REQUEST

Current Zoning: I-1 (light industrial) and R-5 (single family residential)
Proposed Zoning: MUDD(CD) (mixed use development, conditional)

Approximately 8.8 acres located along the north side of Tremont Avenue, east of Toomey Avenue, and west of South Tryon Street.

The petition proposes to allow up to 325 residential units and up to 61,000 square feet of non-residential uses on a site developed with residential, retail, and industrial uses and vacant land located between Interstate 77 and South Tryon Street.

- **Proposed Request Details**

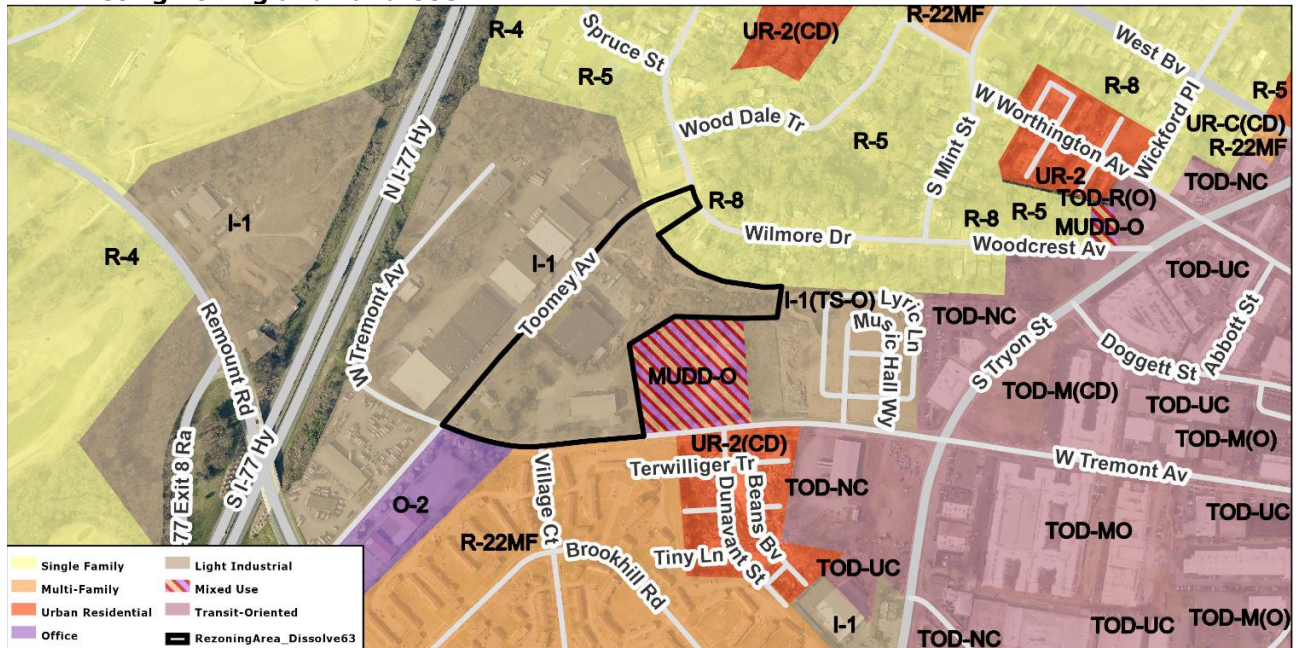
3. Provide a dimension and width for the proposed Class C buffer. Provide a development note committing to the Class C buffer. **Not addressed. The planting strip should be located outside of the easement. Either the planting strip should be provided or not provided at all.**
4. ~~Adjust information to specify the number of multi-family units proposed and number of townhomes proposed.~~ **Addressed**
5. Label setbacks along Toomey Avenue and W. Tremont Avenue in the correct location. **Not addressed**

6. New comment: Petitioner needs to clearly note the proposed 61,000 square feet of non-residential uses under Site Data on Sheet 1. The request is not clearly stated on Sheet 2.
-
